**CITY OF BLOOMINGTON
PLAT COMMITTEE AGENDA**

**BLOOMINGTON PLAT COMMITTEE
STAFF REPORT SECOND HEARING
Location: 1800 W. Tapp Road**

**CASE #: PUD-31-11
DATE: February 6, 2012**

Date: November 2, 2011
To: Bloomington Plan Commission
From: Bloomington Environmental Commission
Through: Linda Thompson, Senior Environmental Planner
Subject: PUD-31-2011 Woolery Planned Community, Phase IX

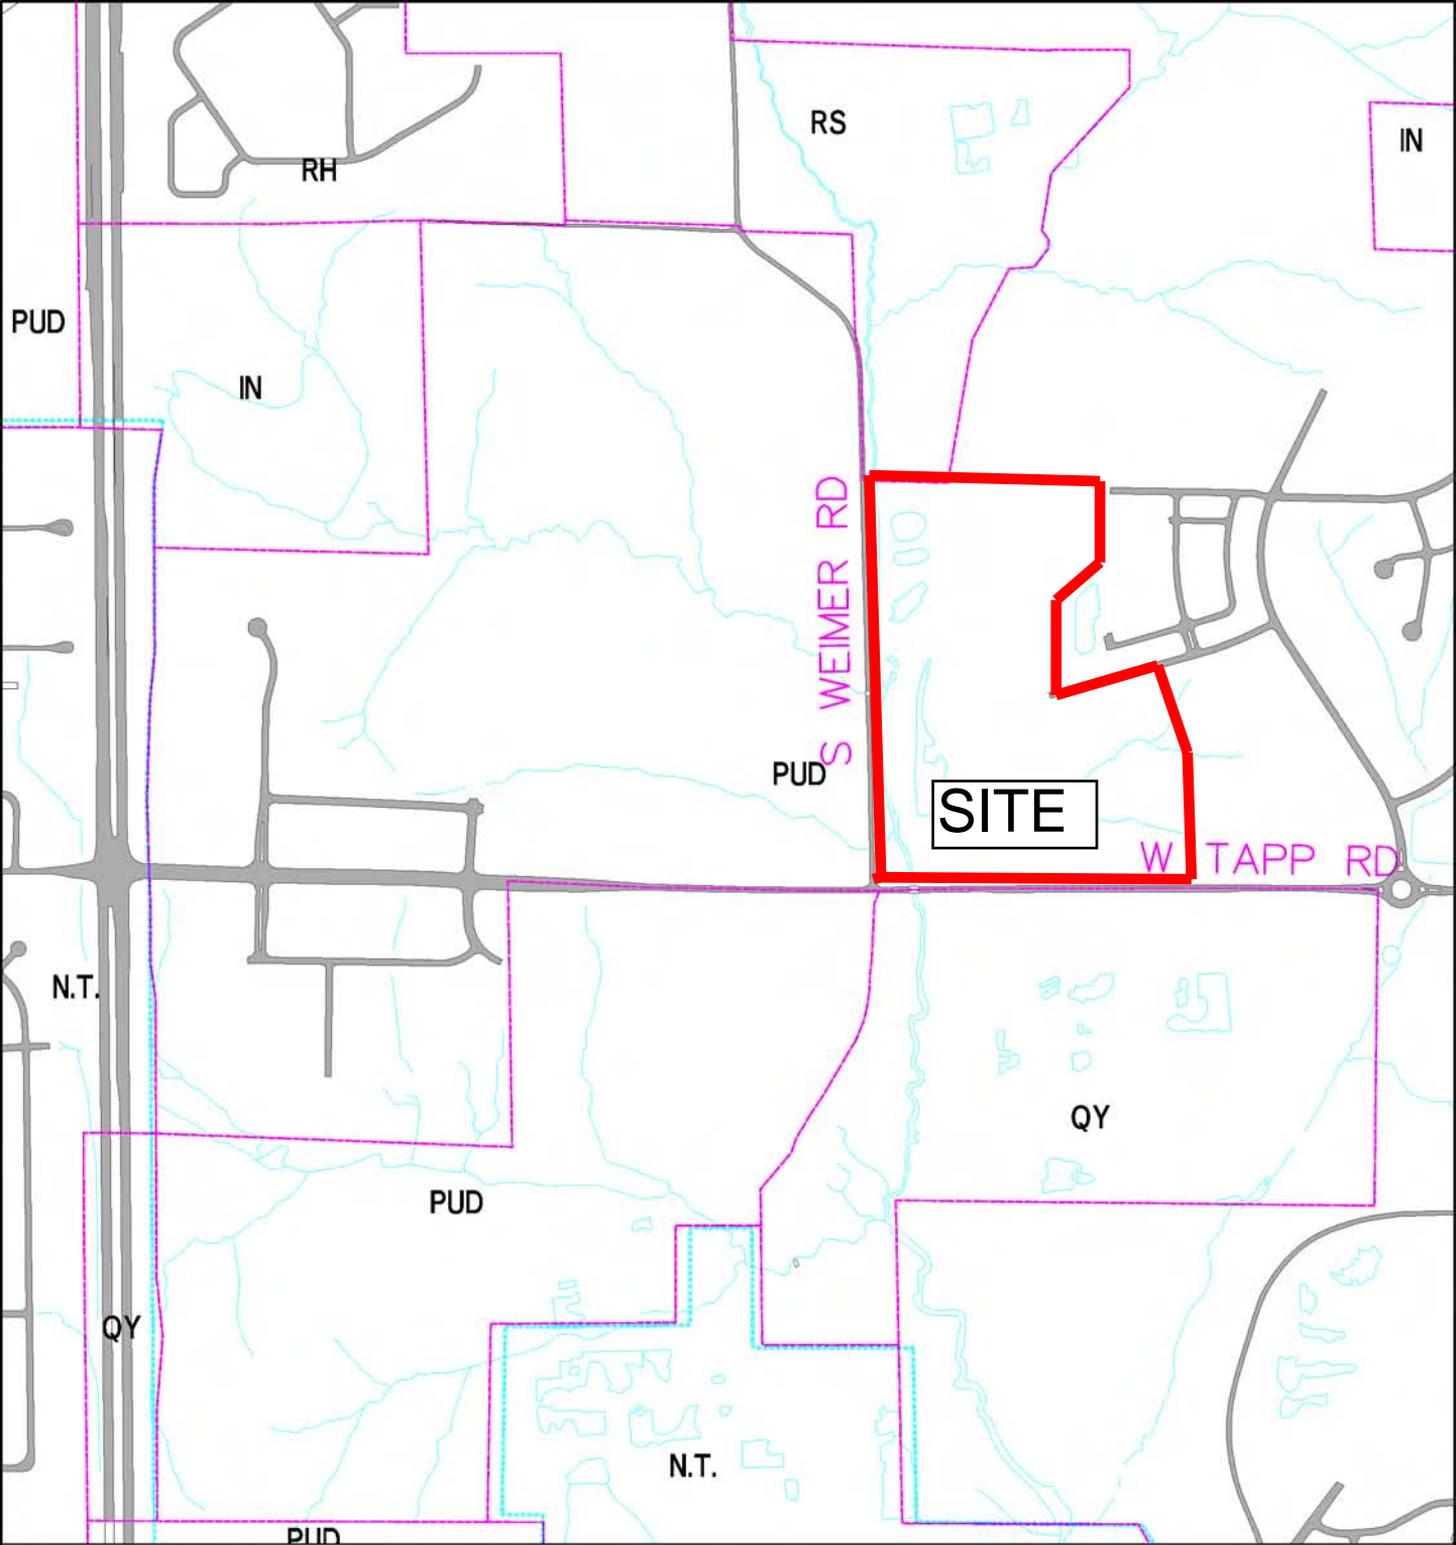
The site is home to several karst or pseudokarst* features in its northeast corner. These sinkhole-looking features were briefly looked at and considered during review of the Woolery Mill Complex PUD-35-01 in 2001. At that time it was unclear if they were naturally-occurring sinkholes, or if they were pseudokarst sinkholes developed from soil piping through fill. Whether or not the soil piping resulted from naturally-occurring dissolution of limestone, or migration through watercourses between unconsolidated materials is not relevant. With either scenario, the features behave like sinkholes in that they are direct conduits to groundwater and should have conservation buffers surrounding them.

The petitioner should take one of two actions before a future Final Plan is submitted for the northeast corner of the site. One choice is to conduct a geologic study of the subsurface to determine the validity and extent of the sinkholes prior to delineating a Karst Conservancy Easement. The other choice is to delineate a Karst Conservancy Easement, with an associated 10 foot building setback, based on the surface expression and regardless of the provenance of the sinkholes.

The EC recommends that before a future Final Plan is approved, the size and shape of the Karst Conservancy Easement, and an associated 10 foot building setback, are defined by either a geologic study of the area, or a topographic interpretation of the last closed contours of the sinkholes.

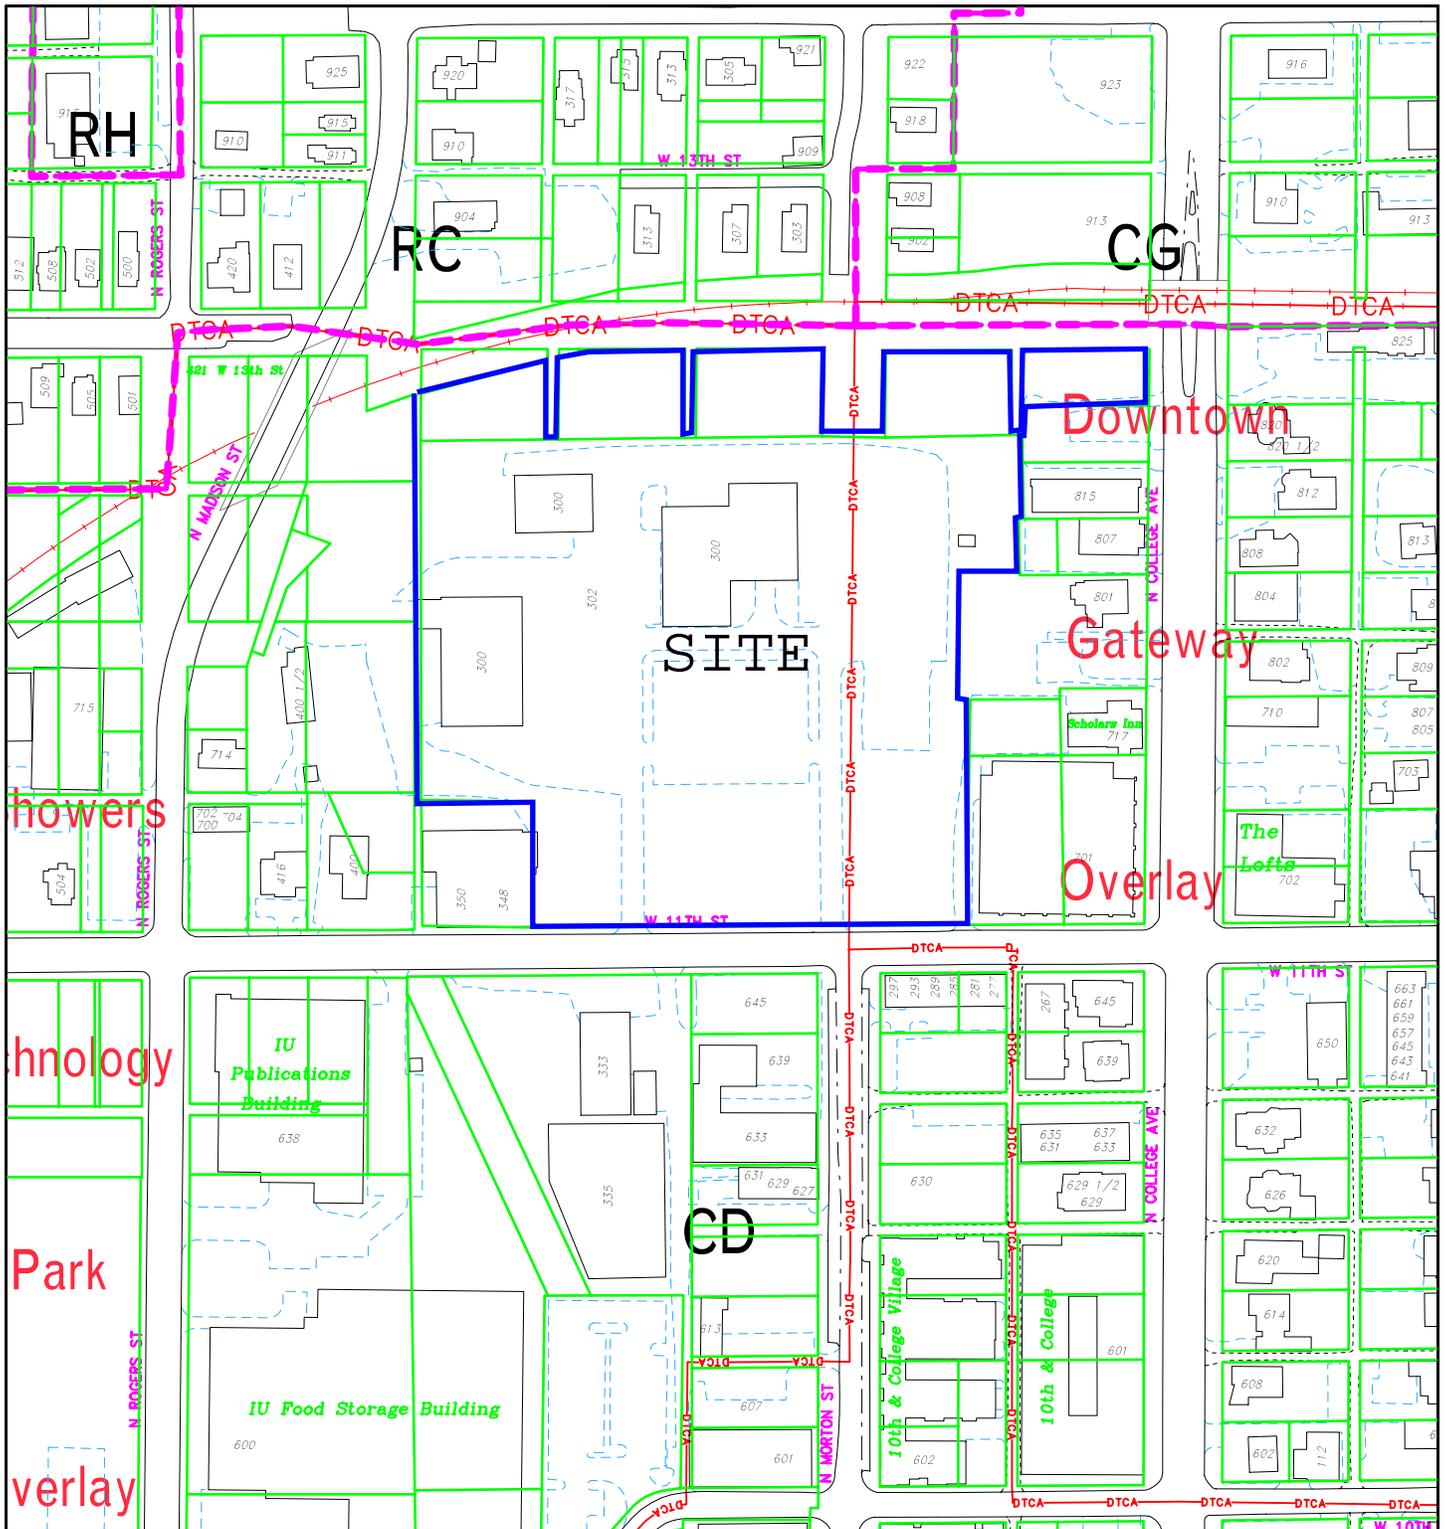
The site will be mostly served by an 18-inch water line that runs through the site in the general location of Morton Street and an existing sanitary sewer line that is located within the 11th St. right-of-way.

Street Lights: Decorative street lights of no more than 15 feet in height are required with this project. Final approval of the lighting plan is required from the Public Works Department prior to installation. In general, four street lights per block face are necessary.
